Re: Sub-Petition No. 1293 LFBNM-01
New Access Road Between Structures #7804 and #7805

New Access Road Between Structures #7804 and #7805

Revised Sub-Petition Maps

Map Sheet 01 of 03
Date: March, 06, 2018

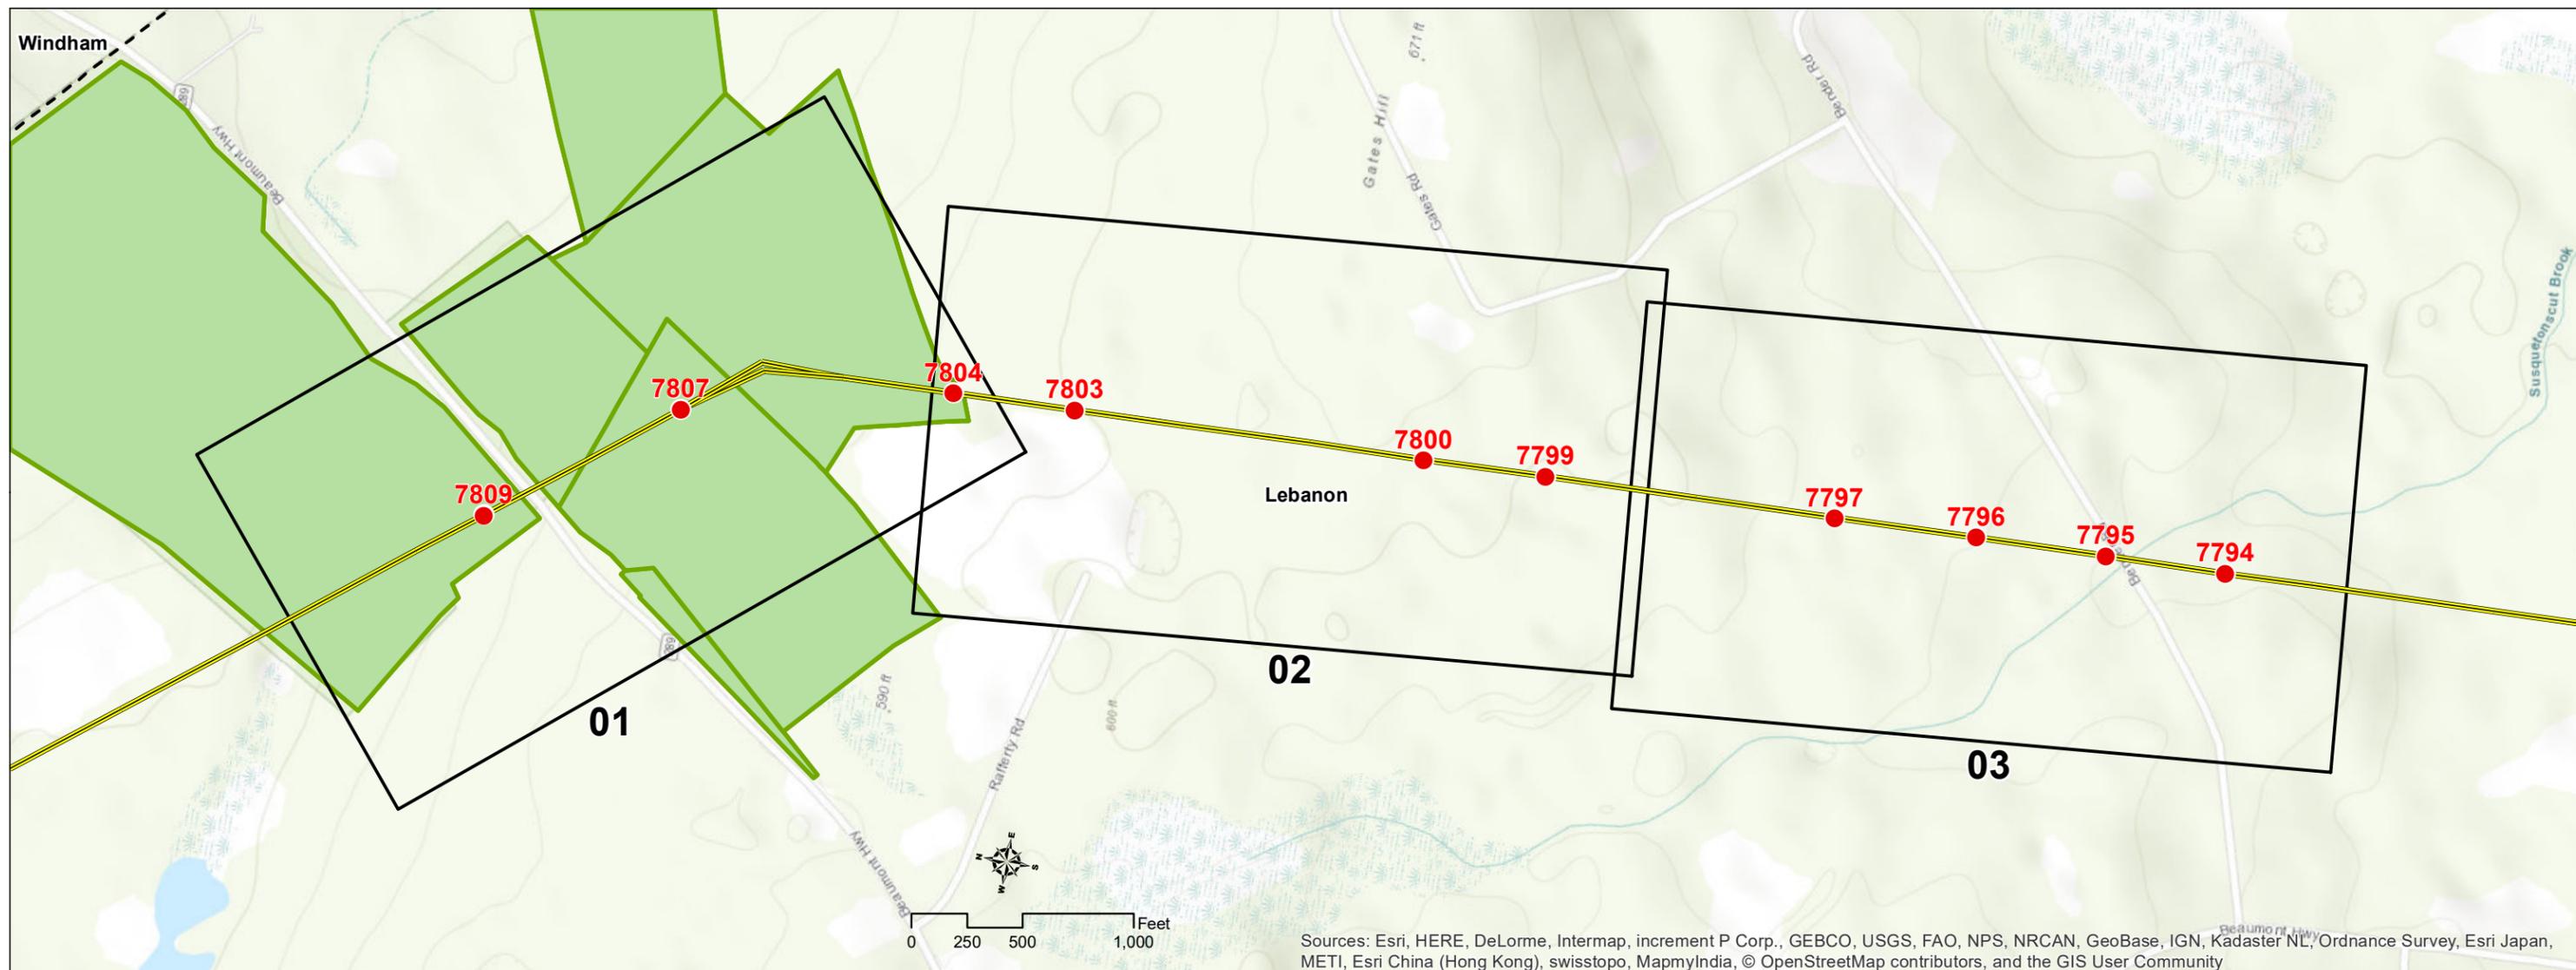
The location of this requested change is between Structures #7804 and #7805, is southeast of Beaumont Highway in the Town of Lebanon and is shown on Sheet 01 of the Revised Sub-Petition Maps dated March 6, 2018 (see Attachment A).

In the approved Petition, Eversource had shown an access road originating from Beaumont Highway and traversing southeast in the Eversource ROW to provide access for the replacement of Structure #7807. After further review of the constructability of this section of the access road between Beaumont Highway and Structure #7808, it has been determined that not only is the slope up from the public road too steep, but there is not sufficient clearance under the Eversource distribution line located along the southeast side of Beaumont Highway to allow for safe movement of construction vehicles from Beaumont Highway onto the ROW. Therefore, Eversource has determined that access to Structures #7805 through #7808 would instead be via Bender Road, shown on Sheets 02 and 03 in Attachment A. This change requires that a new, approximately 360 foot section, of access road to be built between Structures #7804 and #7805. This new section will result in a minor increase (approximately 512 square feet) of temporary wetlands impact.
